REVISED RESPONSE TO REQUEST FOR ADDITIONAL INFORMATION

APR1400 Design Certification

RAI No.: 323-8281
SRP Section: 07.03 – Engineered Safety Features Systems
Application Section:
Date of RAI Issue: 11/30/2015

Question No. 07.03-13

Figure 4.2-1 Overview Diagram of the CIM

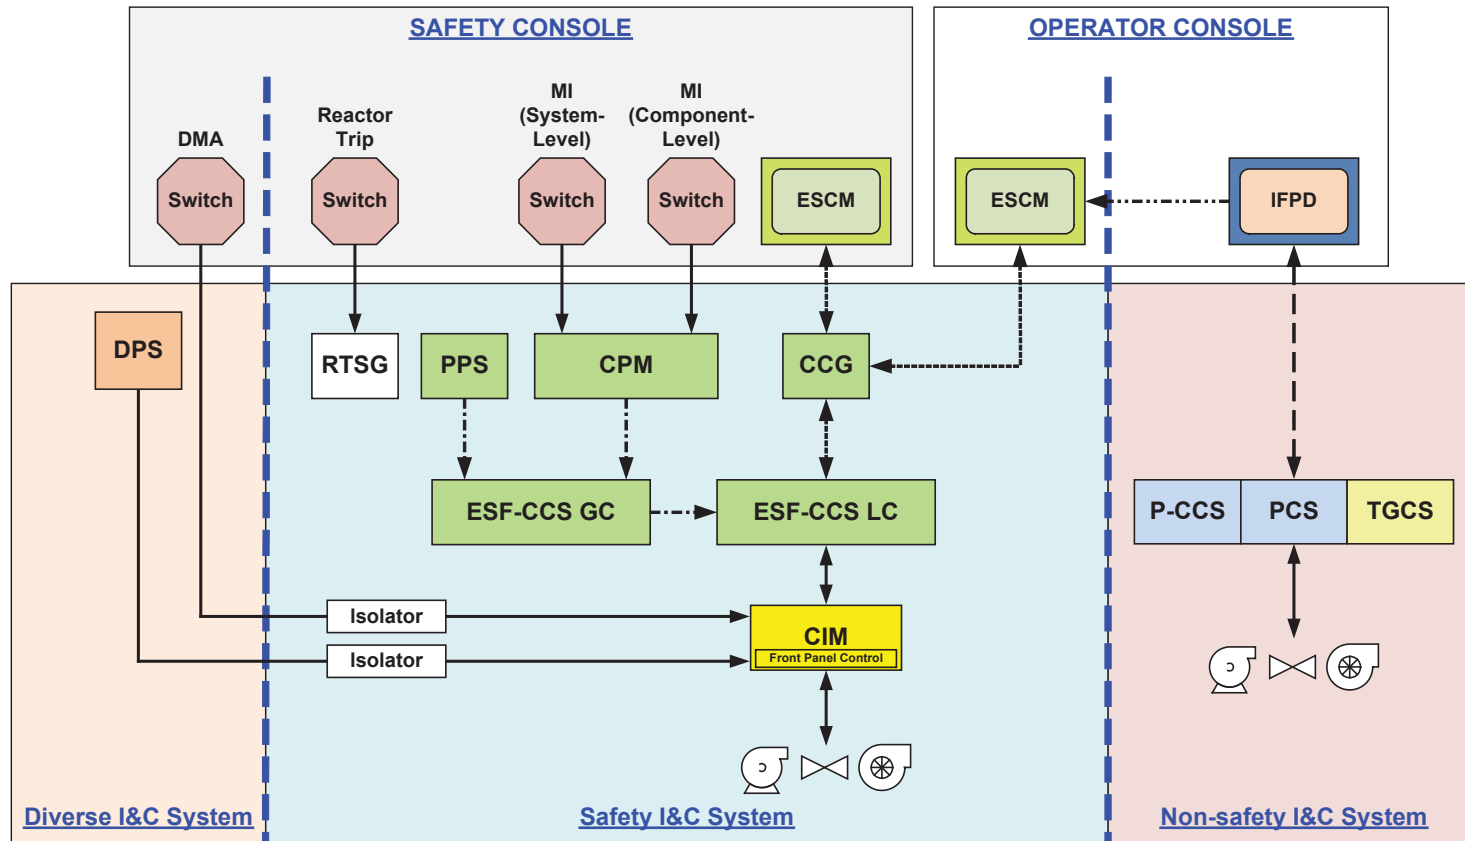
Figure 4.2-1, “ Overview Diagram of CIM,” of Technical Report APR1400-E-J-NR-14001-P, Rev.0, “Component Interface Module,” identifies that signals from the diagnostic section of the CIM are inputs to the safety-related ESF-CCS loop controller. These diagnostic functions are non-safety related. Describe the measures taken to prevent those non-safety diagnostic signals from interfering with the safety functions of the ESF-CCS loop controllers.

The diagnostic section of the component interface module (CIM) and the signals generated by that section are classified as safety grade, as stated in the third bullet of Section 4.2. That paragraph incorrectly states that the diagnosis section is software integrity level 3 (important to safety); but since the hardware of FPGA-based diagnosis section is designed as Class 1E, the application program of diagnostic function is qualified as software integrity level 3 grade (important to safety, ITS) of the software quality, and the engineering tool to configure the diagnostic logic in the FPGA is commercial grade software.

The diagnosis section generates signals that are transmitted to the Information Processing System (IPS) through the engineered safety features-component control system (ESF-CCS) loop controller (LC) and the maintenance and test panel (MTP) for the purpose of monitoring. These signals are used only for monitoring by the IPS; they do not perform any safety function within the ESF-CCS LC. Therefore, these signals completely bypass all component control logic functions within the ESF-CCS LC. This means there is no interface between these monitoring signals and any ESF-CCS LC logic functions

The signals that are used in the component control logic of the ESF-CCS LC (e.g., energized/de-energized, motor control center power fail, coil circuit open) are input to the ESF-CCS LC through the relays on the CIM module in Figure 4.2-1.

The third bullet of Section 4.2 will be revised as indicated in the attachment associated with this response.
